January 15, 2004

Subject: Oconee Nuclear Station  
Docket Numbers 50-269, 270, and 287  
License Amendment Request associated with the  
Digital Control Rod Drive Control System (CRDCS)  
Modification  
Technical Specification Change (TSC) Number  
2003-09

**ATTACHMENT 1**

FIGURE 1

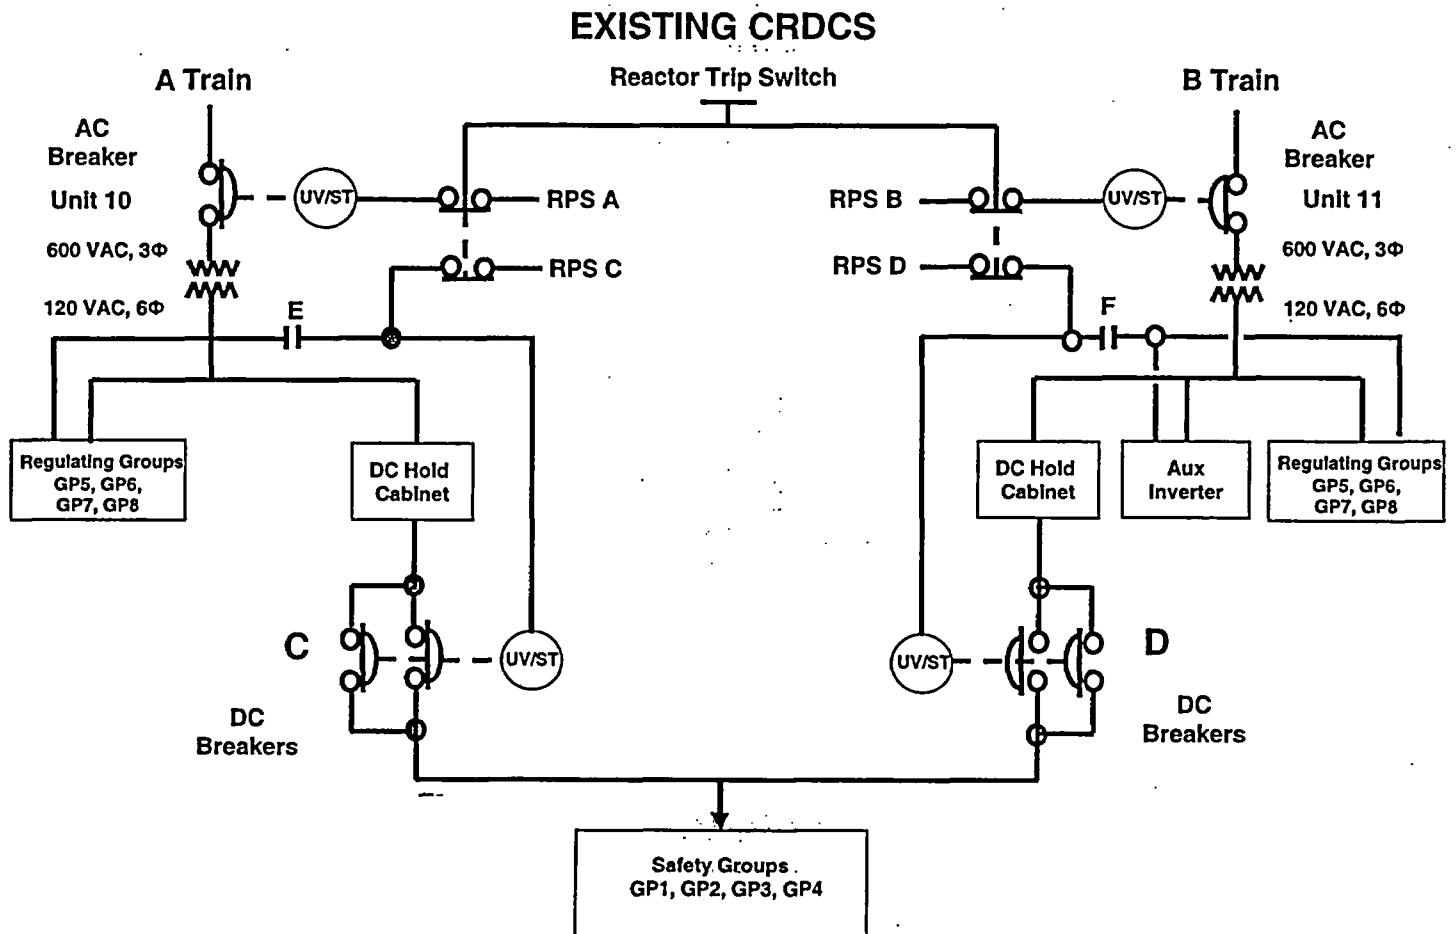
The existing relay based Control Rod Drive Control System (CRDCS) (refer to Figure 1 on page 10 for simplified diagram) is being upgraded to a solid-state programmable digital CRDCS to resolve obsolescence and age-related degradation issues. A Technical Specification change is needed to reflect the new design.

FIGURE 2

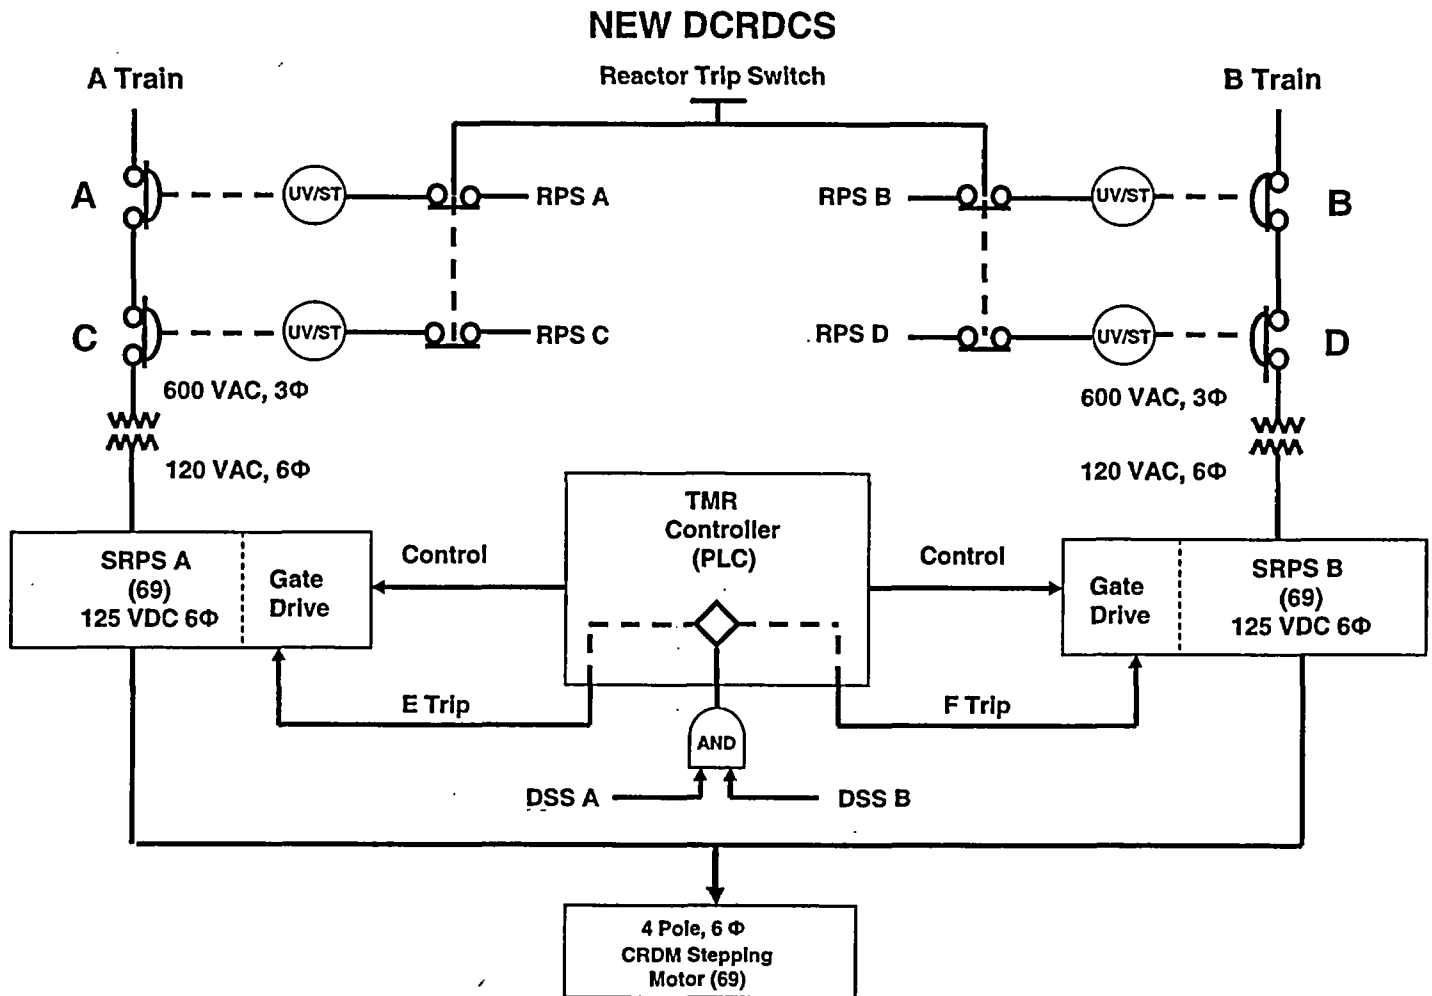
The new digital Control Rod Drive Control System (CRDCS) will be powered from two independent power supplies. Each of these power supplies will connect to the digital CRDCS via two RTBs connected in series (refer to Figure 2 on page 11 for simplified diagram). This arrangement of parallel feeds,
